UNITED STATES
NUCLEAR REGULATORY COMMISSION
REGION III
799 ROOSEVELT ROAD
GLEN ELLYN, ILLINOIS 60137

IE Bulletin No. 80-20

FAILURES OF WESTINGHOUSE TYPE W-2 SPRING RETURN TO NEUTRAL CONTROL SWITCHES

FIGURE 1:

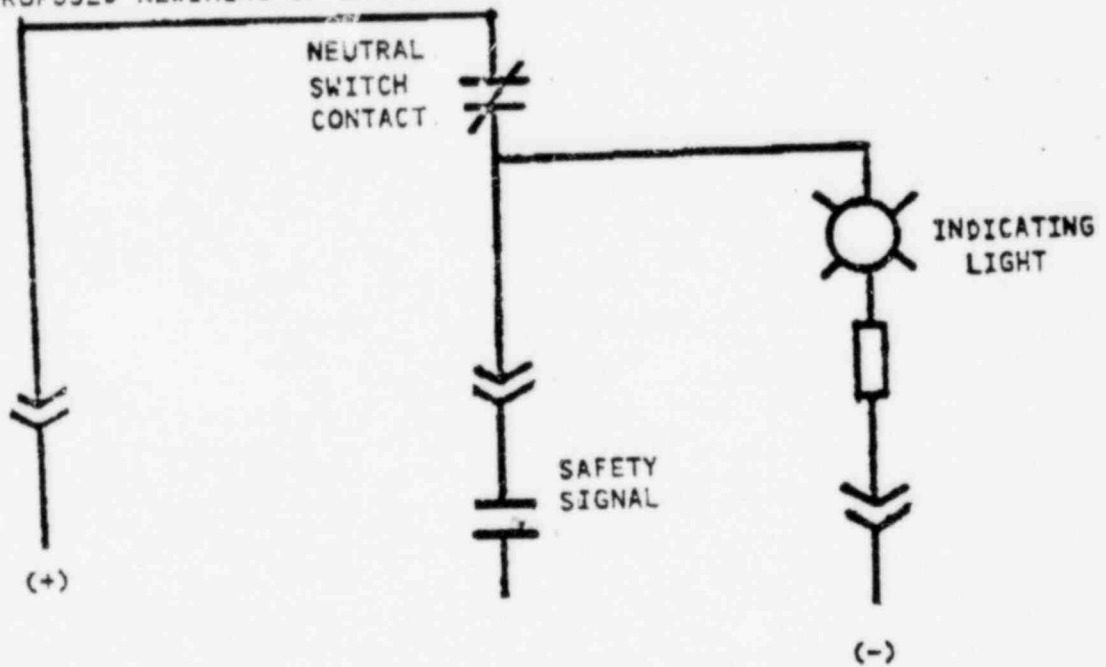
A review of this matter by Westinghouse led to the issuance of NSD Technical Bulletin No. NSD-TB-80-9 to the utility owners of all Westinghouse operating plants. The recommendations contained in the Westinghouse technical bulletin include: (i) testing the neutral position contacts of the subject W-2 switches for continuity, and (ii) rewiring of the indicating light circuit to permit the early detection of a neutral contact failure as shown in Figure 1.

Depending on how the indicating light circuit is wired, loss of continuity thru the neutral position contact of a W-2 switch could remain undetected until the equipment associated with the switch were called upon to operate. Since such a failure would be equivalent to by-passing the system associated with the switch, consideration should be given to rewiring the switches used in safety-related applications as shown in Figure 1. Such rewiring would provide an acceptable means for detecting contact failure, provided the indicating light is in the control room and readily visible by the operator. If the indicating light is not so located, consideration should be given to annunciating the neutral position contact failures at the control room to alert the operator of the inoperable status of a safety-related system. In addition, consideration should be given to adding redundant contacts to the W-2 switches or to replacing the W-2 switches with others having a more positive contact wiping action.

3. Licensees of operating plants and holders of construction permits shall describe the longer term corrective measures planned and the date by which such measures will be implemented by actual installation or by design change, as appropriate. As a minimum, the longer term corrective measures should include rewiring the indicating light as shown in Figure 1 provided the light is readily visible to the control room operator. If not, failures of the neutral position contacts should be annunciated in the control room.

REWIRING OF INDICATING LIGHT CIRCUIT OF W-2 SWITCHES
AS RECOMMENDED BY WESTINGHOUSE TECHNICAL BULLETIN NSD-TB-80-9
